OPTIONAL SERVICE BULLETIN NO. DA20-27-09 REV. 0

All DA 20-A1 aircraft.

Installation of the Diamond Aircraft flap control module unit and microswitch tray.

FIGURE 1.3 (SHOWS WIRING AFTER ALL WORK IS DONE)

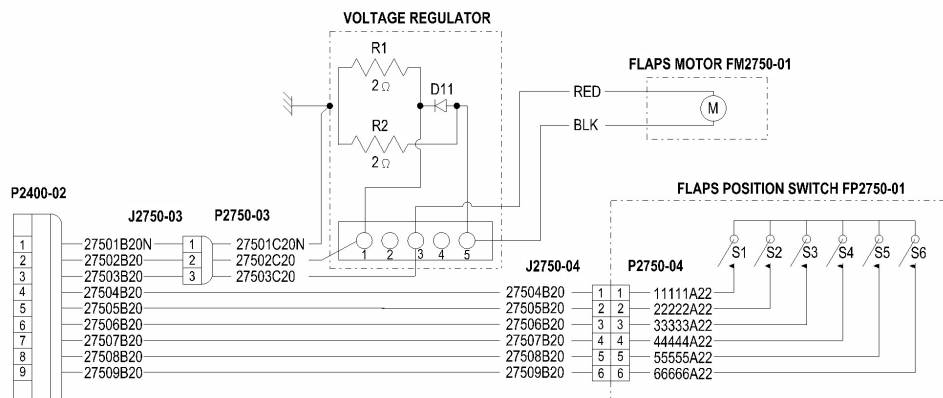
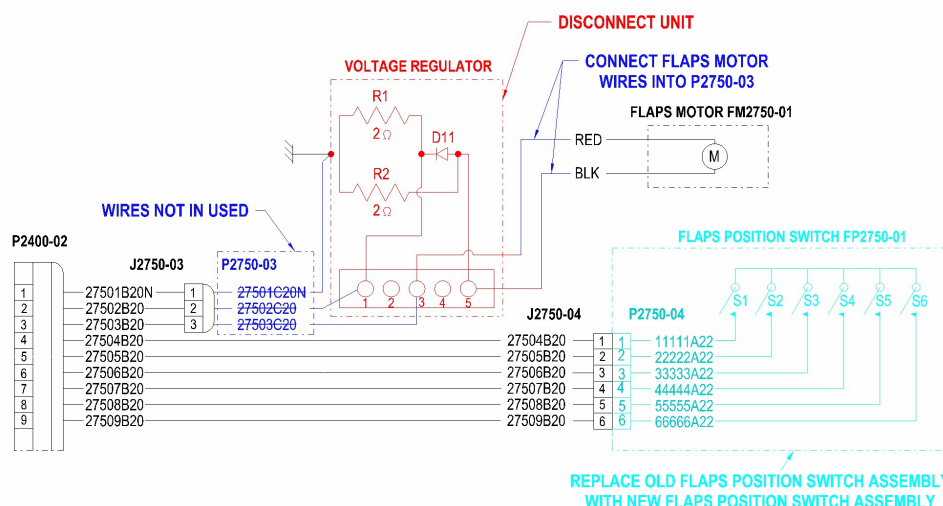
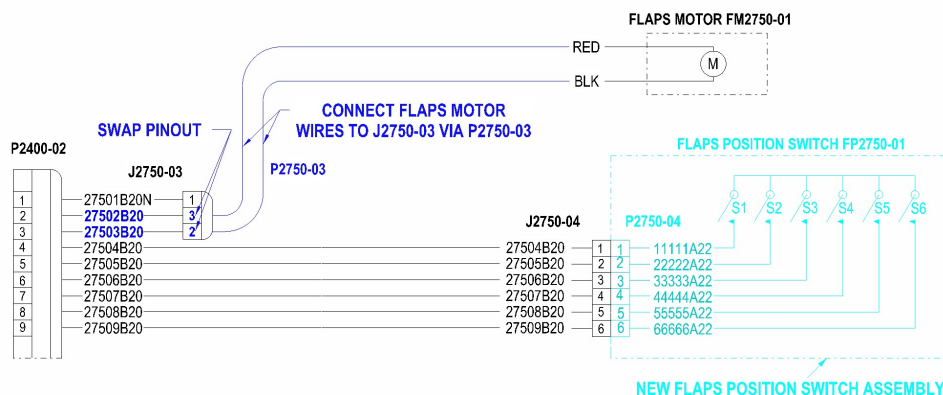
Figure 1.1 shows the original wiring currently in the aircraft, Figure 1.2 shows the original wiring with the proposed fix, and Figure 1.3 shows the wiring after all the work is done.

9. Disconnect all wires from the voltage regulator; reference Figures 1.2 and 1.3.
10. Swap flap motor wires 27502B16 and 27503B16 or RED and BLACK in connector P2750-03 in the aircraft; reference Figures 1.2 and 1.3. Connect the P2750-03 connector into the J3750-03 connector.
11. Connect the J2750-04 connector to the new flaps position switch assembly.

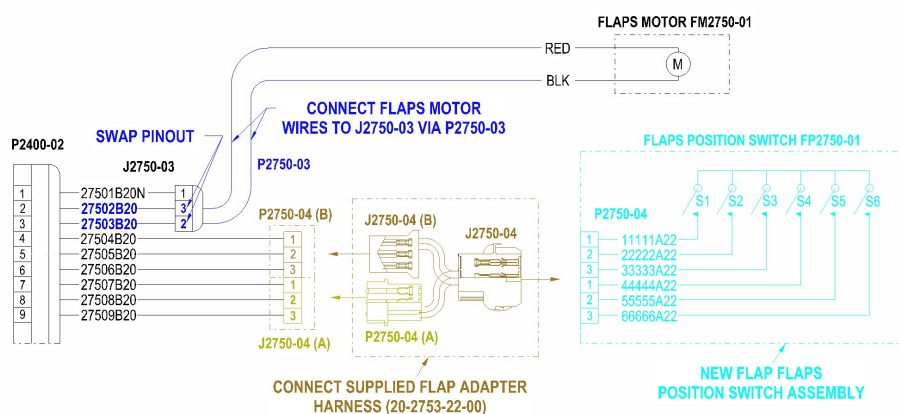
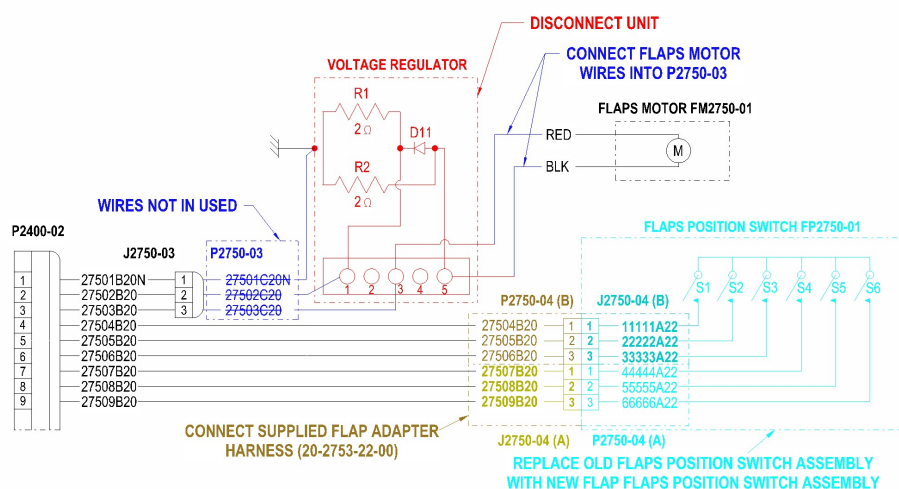
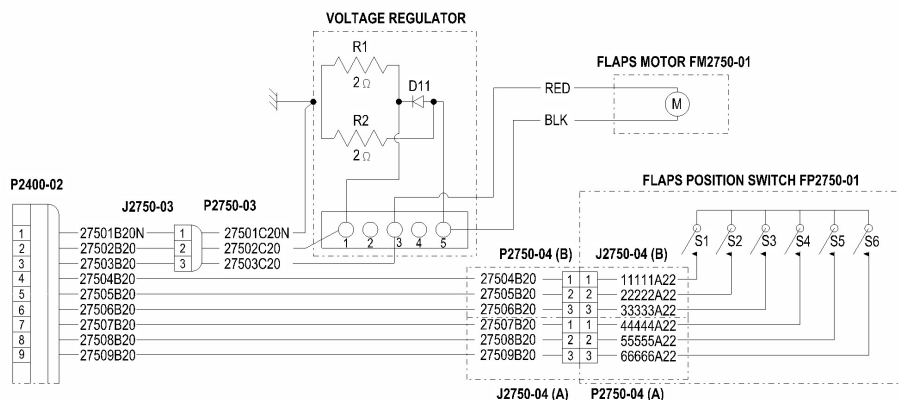
Figure 2.1 shows the original wiring currently in the aircraft, Figure 2.2 shows the original wiring with the proposed fix, and Figure 2.3 shows the wiring after all the work is done.

13. Disconnect all wires from the voltage regulator; reference Figures 2.2 and 2.3.
14. Swap flap motor wires 27502B16 and 27503B16 or RED and BLACK in connector P2750-03 in the aircraft; reference Figures 2.2 and 2.3. Connect the P2750-03 connector into the J3750-03 connector.
15. Connect the two 3-pin connectors (J2750-04 A and P2750-04 B) into the supplied adaptor harness (20-2753-22-00). Connect the other end (J2750-04 connector) of the supplied adaptor harness (20-2753-22-00) new flaps position switch assembly.
